**NORTHTRAIL OFFICE PARK**  
6601 N CAPITAL OF TEXAS HWY NB, AUSTIN, TX 78731

SPC-2023-0357C

**Subject:** IP Concerns -- SPC-2023-0357C North Trail Office Park

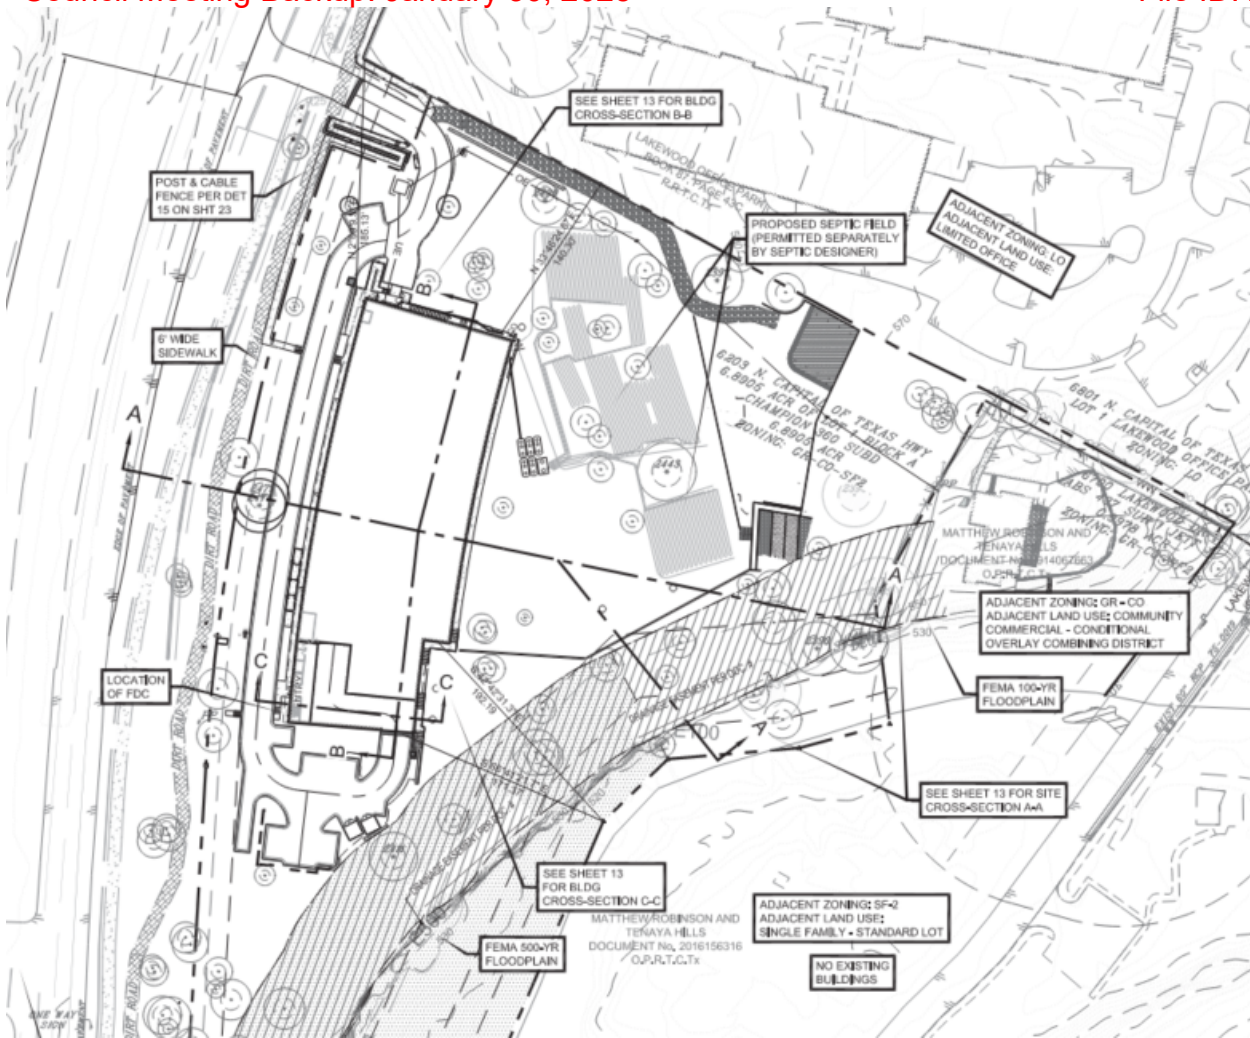
It remains unclear to me how a septic field, positioned just over 75 feet from a bluff, adjacent to Bull Creek doesn't pose a threat to the creek and wildlife and therefore how it is afforded approval by the City.

I'd appreciate the time & attention of a reviewer to educate me on this. Is <100 feet of travel through limestone sufficient to make the septic discharge safe to enter our water?

Regarding the concerns of the OSSF discharging into the creek, I believe that would be addressed by the AW reviewer?

I do see that it is noted to be separately permitted so am not sure if that has gone through that process yet.

The plans show the OSSF is between the pond and building so there are no conflicts with the DE/WQ design.
